**Technical Service  
Information Bulletin**

**TONNEAU COVER LATCH RATTLE**

'04 – '06 RX 330, '06 – '07 RX 400h, &  
'07 RX 350

NVH  
NV001-07

**Parts Information**

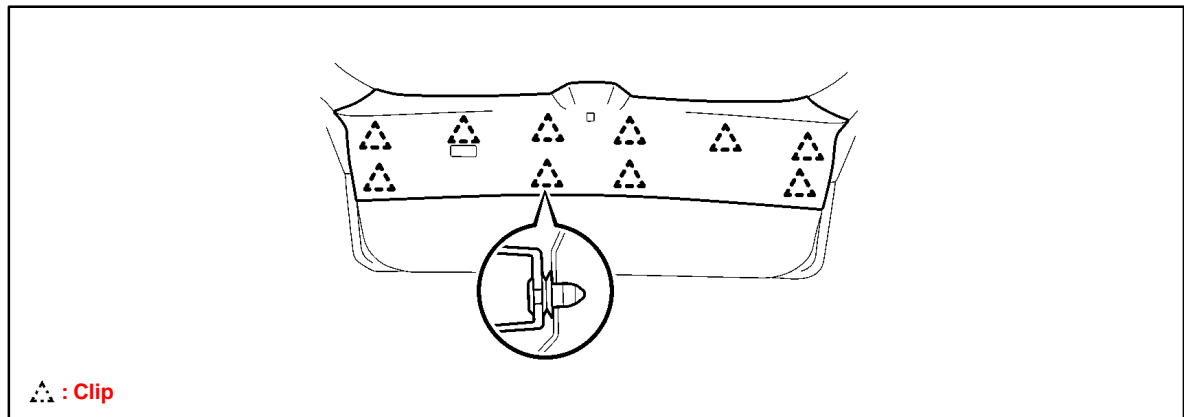
**Introduction** Some customers may experience a rattle noise from the rear of the vehicle when going over bumps. This problem is due to lack of insulation and excessive clearance between the tonneau cover locks and the back door trim spacers. Perform the following procedure to correct this condition.

PREVIOUS PART NUMBER	CURRENT PART NUMBER	PART NAME	QTY
67754-48010-##	67754-48050-##	Spacer, Back Door Trim RH	1
67754-48020-##	67754-48060-##	Spacer, Back Door Trim LH	1

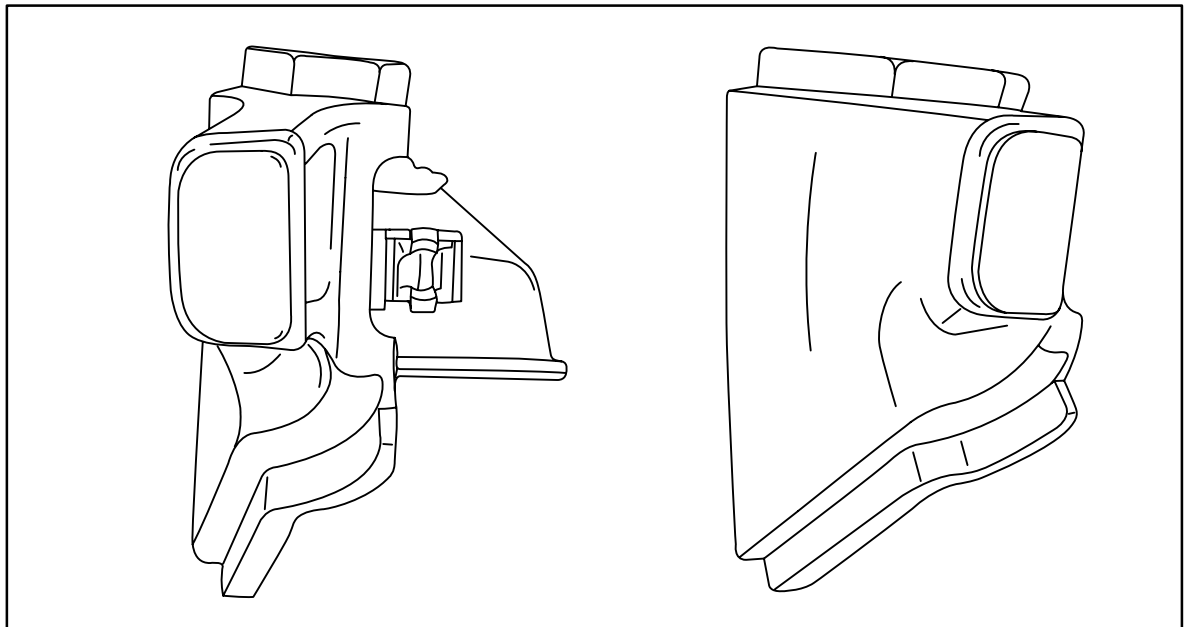
3. Remove the screw and then remove the back door trim spacer RH and LH.

4. Replace the back door trim spacer RH and LH with a NEW one.
